UNITED STATES PATENT AND TRADEMARK OFFICE

APPLICATION NO.	FILING DATE	FIRST NAMED INVENTOR	ATTORNEY DOCKET NO.	CONFIRMATION NO.
10/585,530	08/07/2007	Yuji Fujita	SANKY P-322/500615.20299	4418
26418 7590 03/06/2009 REED SMITH, LLP ATTN: PATENT RECORDS DEPARTMENT 599 LEXINGTON AVENUE, 29TH FLOOR NEW YORK, NY 10022-7650			EXAMINER HASAN, MOHAMMED A	
			ART UNIT 2873	PAPER NUMBER
			MAIL DATE 03/06/2009	DELIVERY MODE PAPER

Office Action Summary	Application No. 10/585,530	Applicant(s) FUJITA ET AL.	
	Examiner Mohammed Hasan	Art Unit 2873

Fig. 1

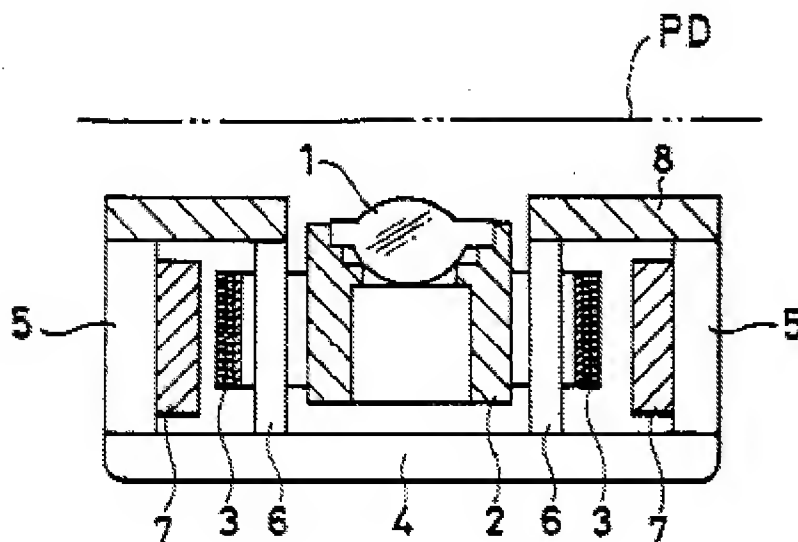
Regarding claim 1, Ohno discloses (refer to figure 1) a lens drive unit comprising: a movable lens body equipped with a lens (1) ; a drive means to move the movable lens body in an optical axis direction of the lens; a fixing body to support the movable lens body in such a manner to enable the movable lens body to move in the optical axis direction; and retaining a position of the movable lens body at both ends of an entire motion range in the optical axis direction; wherein the movable lens body is equipped with a first magnetic means (7) as the drive means; the fixing body is equipped with a second magnetic means (7) as the drive means which is placed so as to enable the movable lens body to move by one of magnetic attraction force and magnetic repulsion force caused between the first magnetic means and the second magnetic means; and furthermore, and one of the position retaining member and the movable lens body relatively moves so as to move the touching section for having the touching section touch at the movable lens body to retain the movable lens body at the middle position so that the number of retaining positions of the movable lens body increase from both the two ends of the entire motion range (column 3, lines 40-65).

Regarding claim 2, Ohno discloses, wherein one of the position retaining member and the movable lens body rotates relatively by using the optical axis as a rotating center so as to move the touching section for having the touching section touch at the movable lens body to retain the movable lens body at the middle position (as shown in

Regarding claim 4, Ohno discloses wherein the first magnetic means (7) is materialized by one of a drive magnet and a drive coil; the second magnetic means (7) is materialized by the other side elements of a couple of drive magnets and a couple of drive coils which are placed separately at both sides of the first magnetic means in the optical axis direction; the middle position is materialized under a positioning condition in which the first magnetic means is in proximity to the second magnetic means; and at the middle position, the movable lens body is touched to the touching section under forced condition, by magnetic attraction force between the drive magnet and a back yoke of the drive coil (as shown in figure 1).

Regarding claim 5, Ohno discloses wherein the position retaining member is located at a side of an image pickup device (as shown in figure 1).

Regarding claim 6, Ohno discloses wherein the touching section retains the movable lens body at the middle position by touching at an end surface in the optical axis direction of the movable lens body (as shown in figure 1).

Regarding claim 7, Ohno discloses wherein the position retaining member gets moved so as to move the touching section for having the touching section touch at the movable lens body to retain the movable lens body at the middle position (as shown in figure 1).
